**Technical Service Bulletin**

**PATIENT MONITORS**

**Date: 2014-08-25**

<b>Subject:</b>	TSB-LXi HANDLE HOUSING SCREW REPLACEMENT
<b>Distribution Scope:</b>	Welch Allyn Global Technical Support, Product, Field & Customer Service Teams, & WA ASP's.
<b>Product(s) Referenced:</b>	All SPOT 4500 LXIs 421037 / SCR,4-20X.31 PLASTITE PH TORX (SHORT) 713015 / SCREW, PLASTITE #4-20 X .500 PAN HEAD (LONG) 700103 / HSG, REAR, ULTRA 700101 / HSG, HANDLE, ULTRA
<b>Summary:</b>	Welch Allyn manufacturing is lengthening the screws used to fasten the rear housing (700103) to the handle housing (700101) to address the occurrence of the shorter plastite (self-tapping) screws (421037) stripping out the screw bosses of the handle housing.
<b>Issue:</b>	The shorter screws that were used to attach the rear housing to the handle housing have been found to strip out the screw bosses of the handle housing.

Use 713015 (longer) screw!

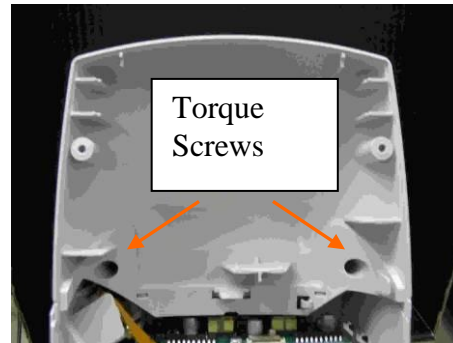
If, during a repair, it is necessary to reassemble the rear housing to the handle housing, attach the rear housing (700103) onto the handle housing (700101) using two **long** screws (713015). Torque to 3.75 +/- .4 inch lbs.
